MS-7C52 Ver:1.0

CPU:
AMD AM4
System Chipset:
Promontory A320
(Value DIY or System Builder)

FUSION BLOCK DIAGRAM

CPU POWER CONNECTOR

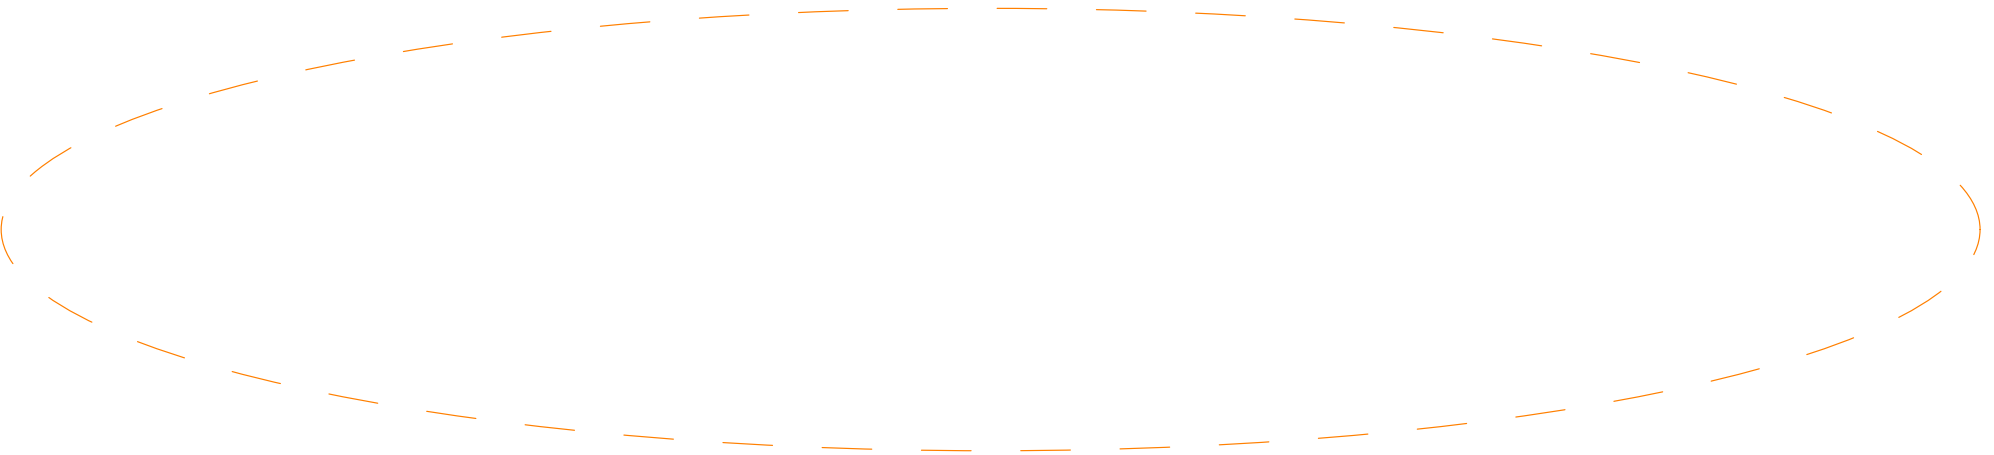
2019/4/11
CPU_PWR1 is changed to N93-04M0441-H06 by PM spec.

2019/4/11
CHOKE1, SP1, SP2 are deleted by Ryan's comment

EZ Debug LED

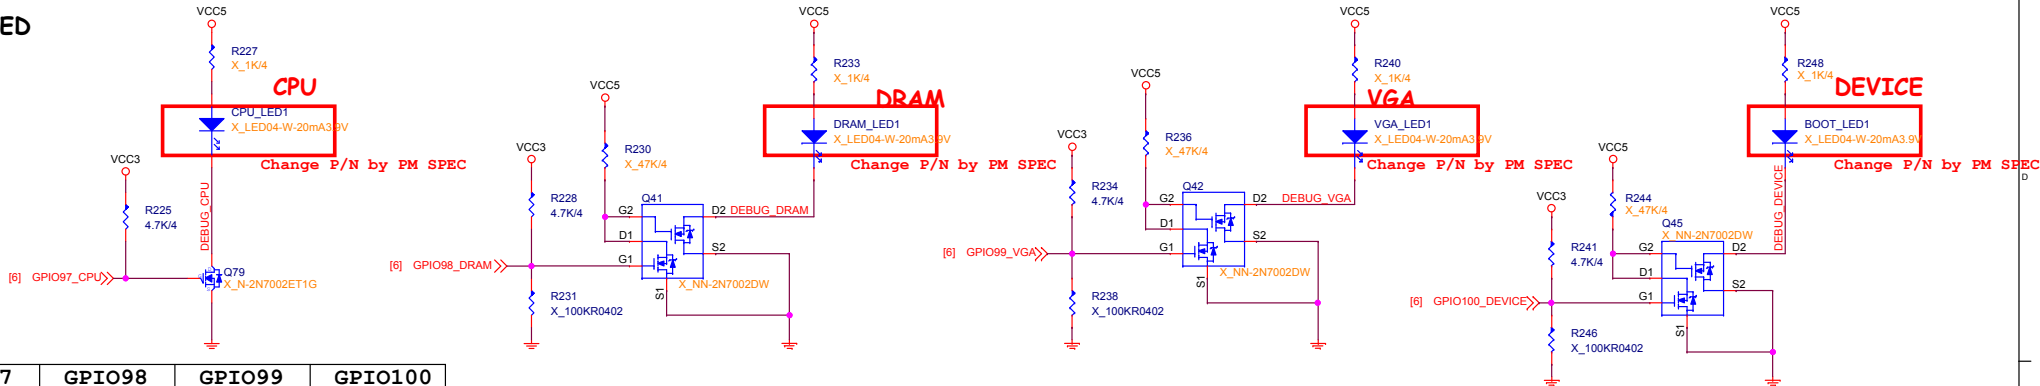
2019/5/2
R227, CPU_LED1, Q79, R223, DRAM_LED1, Q41, R230, R240, VGA_LED1, Q42, R236, R248, BOOT_LED1, Q45, R244 are unstuffed by PM spec updated.

M.2 Connector

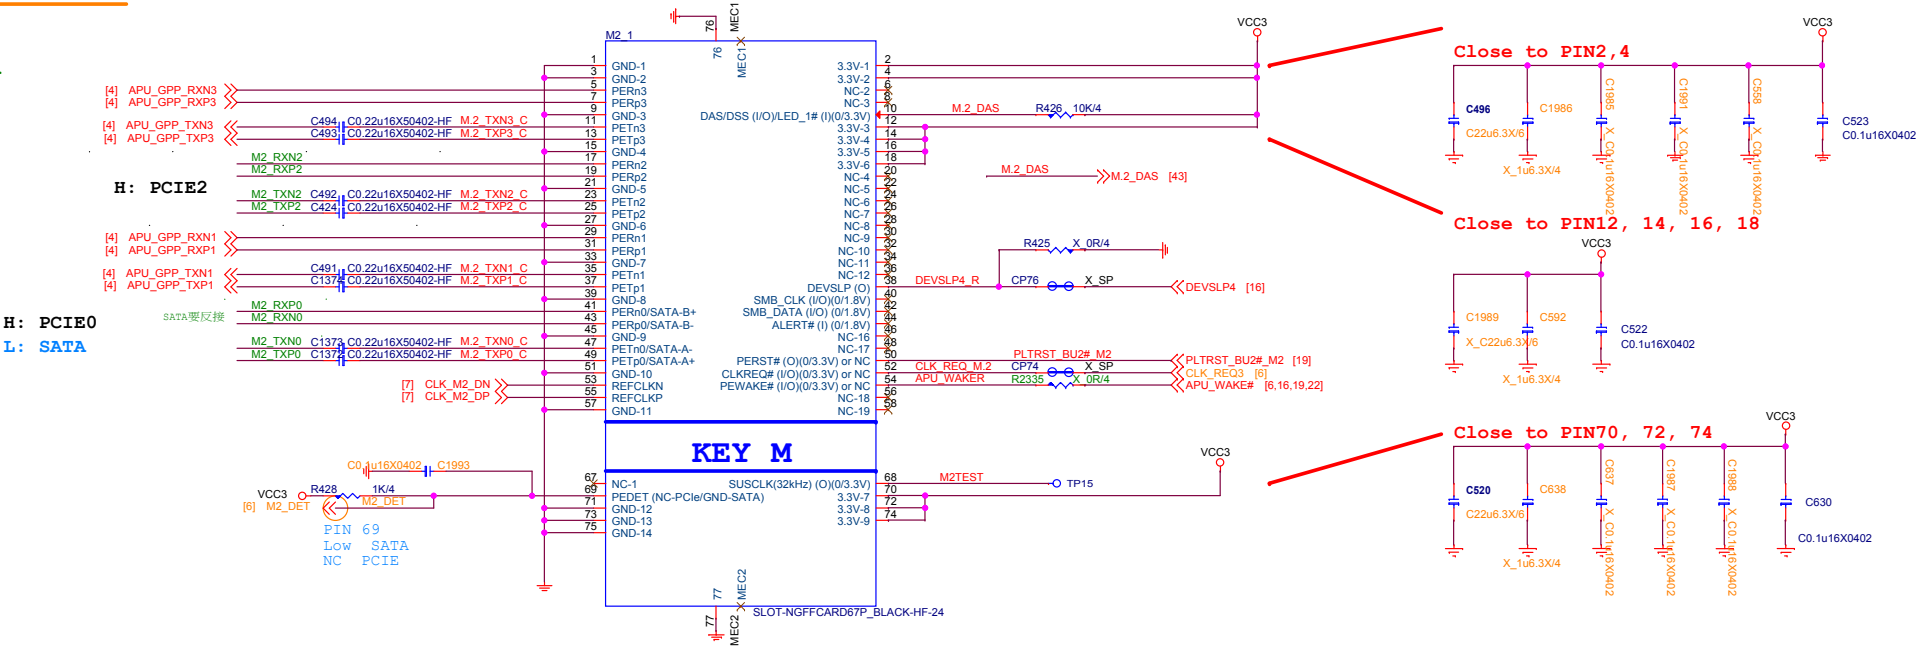
2019/5/21
SCREW2 is add by FM request
